**Callaway Unit No. 1
Renewed Facility Operating License NPF-30
NRC Docket No. 50-483**

**Revise Technical Specifications to Adopt Applicable Elements of
TSTF-439, Revision 2, "Eliminate Second Completion Times Limiting Time From
Discovery of Failure to Meet and LCO"**

Description and Assessment Specific to TSTF-439

Example 1

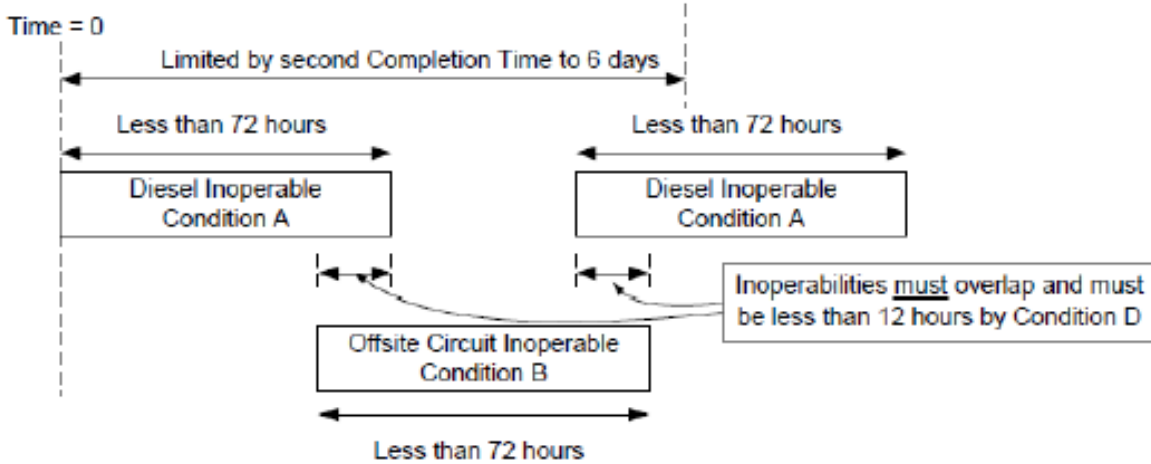
Specification 3.8.1, "AC Sources - Operating," has a 72-hour Completion Time for one offsite circuit inoperable (Condition A) and a 72-hour Completion Time for one diesel generator inoperable (Condition B). Both Condition A and Condition B have a second Completion Time of "6 days from discovery of failure to meet the LCO." The second Completion Time limits plant operation when Condition A or B is entered, and before the inoperable system is restored, the other Condition is entered, and then the first inoperable system is restored, and before the remaining inoperable system is restored, the other Condition is entered again. This highly improbable scenario is further limited by Condition D which applies when an offsite circuit and a DG are inoperable. It limits plant operation in this Condition to 12 hours. See Example 1 for an illustration.

As stated above, the Reactor Oversight Process monitors the availability of mitigating systems, including the emergency AC sources (DG unavailability). Such frequent, repeated failures of the AC sources would be reported to the NRC and this represents a strong disincentive to such operation.

Example 2

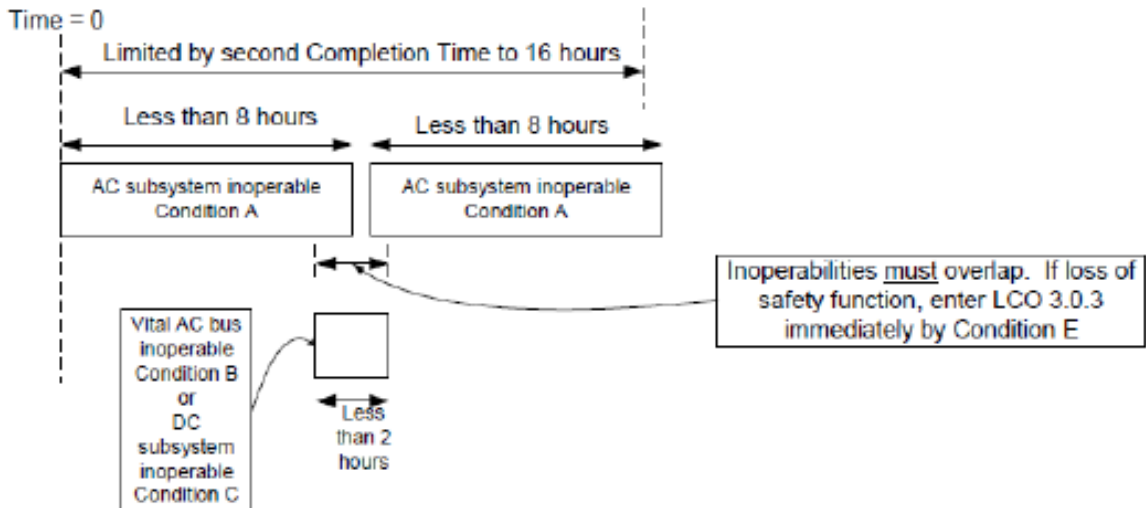
Specification 3.8.9, "Distribution Systems - Operating," has an 8-hour Completion Time for one or more AC electrical power distribution subsystems inoperable (Condition A), and a 2-hour Completion Time for one or more AC vital buses (Condition B) or one or more DC electrical power subsystems (Condition C) inoperable. Conditions A, B, and C have a second Completion Time of 16 hours from discovery of failure to meet the LCO. Condition E applies if two or more electrical distribution subsystems are inoperable and, if it results in a loss of safety function, LCO 3.0.3 must be entered immediately. See Example 2.

The second Completion Time is not needed. First, it is unusual for an AC electrical power subsystem or AC vital bus to be inoperable without causing a reactor trip. Secondly, Completion Times are very short (8 and 2 hours), providing little time to restore systems such that the Conditions overlap and multiple inoperabilities occur. Lastly, should any overlapping inoperabilities that result in a loss of safety function occur, a plant shutdown in accordance with LCO 3.0.3 is required.

Example 3

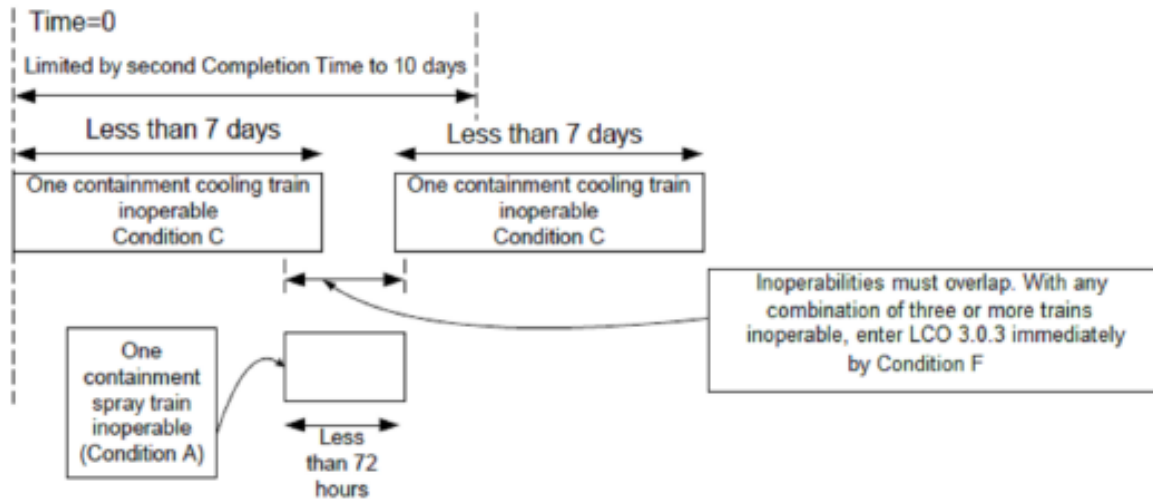
Specification 3.6.6A, "Containment Spray and Cooling Systems (Credit taken for iodine removal)," has a 72-hour Completion Time for one containment spray train inoperable (Condition A) and a 7-day Completion Time for one containment cooling train inoperable (Condition B). Conditions A and B have a second Completion Time of 10 days from discovery of failure to meet the LCO. Condition F also states that if two containment spray trains are inoperable or any combination of three or more trains are inoperable, LCO 3.0.3 must be entered immediately. Specification 3.6.6B, "Containment Spray and Cooling Systems (Credit not taken for iodine removal)," has a 7-day Completion Time for one containment spray train inoperable (Condition A) and a 7-day Completion Time for one containment cooling train inoperable (Condition B). Conditions A and B have a second Completion Time of 14 days from discovery of failure to meet the LCO. Condition G also states that if any combination of three or more trains are inoperable, LCO 3.0.3 must be entered immediately. See Example 3 for an illustration of Specification 3.6.6A.

The second Completion Time is not needed. Any combination of two of the four trains can perform the safety function. Adverse combinations require entry into LCO 3.0.3. The second Completion Time restricts operation with only one train inoperable, but that is unnecessary because when one train is inoperable, there are still three operable trains and only two trains are needed to perform the safety function. Therefore, the second Completion Time is overly restrictive.

Example 4

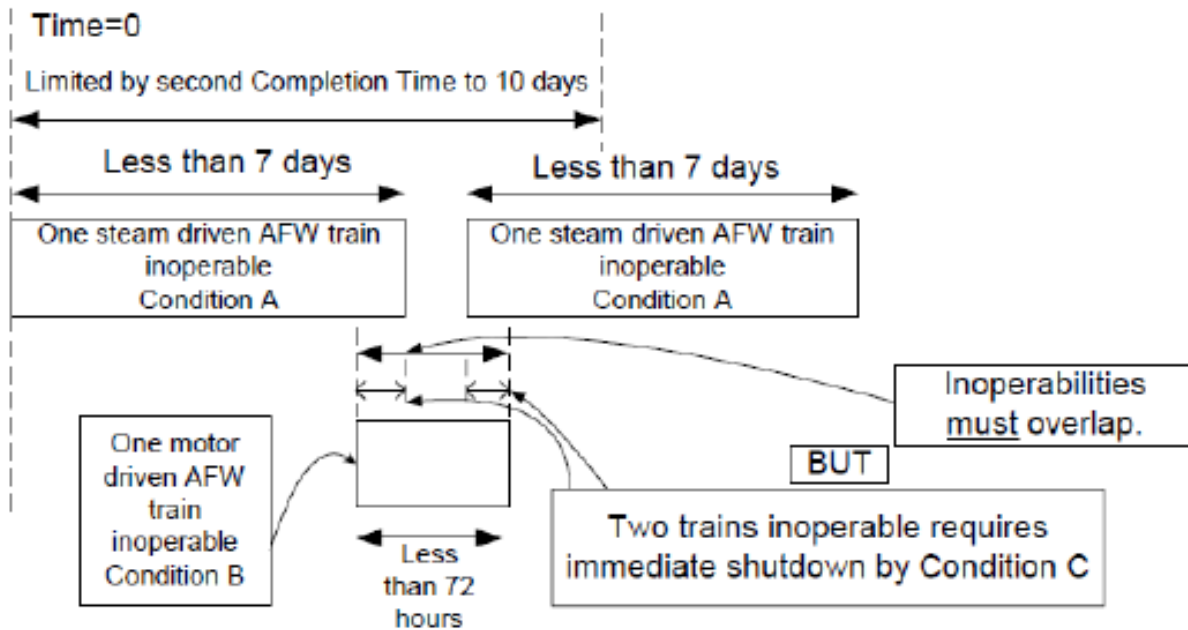
Specification 3.7.5, "Auxiliary Feedwater System (NUREG-1430 - Emergency Feedwater System)," has a 7-day Completion Time for one inoperable steam supply to a turbine driven AFW pump (rendering the turbine driven AFW pump inoperable) (Condition A) and a 72-hour Completion Time for one AFW train inoperable (Condition B). Conditions A and B have a second Completion Time of 10 days from discovery of failure to meet the LCO. In order for the second Completion Time to be limiting, entry into and out of Conditions A and B must occur, which requires the turbine driven and motor driven AFW pumps to be concurrently inoperable. However, Condition C states that if AFW trains are inoperable the plant must be in MODE 3 in 6 hours and MODE 4 in 18 hours. See Example 4.

The second Completion Time is not needed. For the second Completion Time to be limiting, Conditions A and B must be entered concurrently. However, Condition C requires an immediate shutdown when two trains are inoperable. Therefore, the second Completion Time will never be limiting and can be removed. In addition, the Reactor Oversight Process monitors the availability of the AFW system. Such frequent, repeated failures of the AFW system would be reported to the NRC and this represents a strong disincentive to such operation.
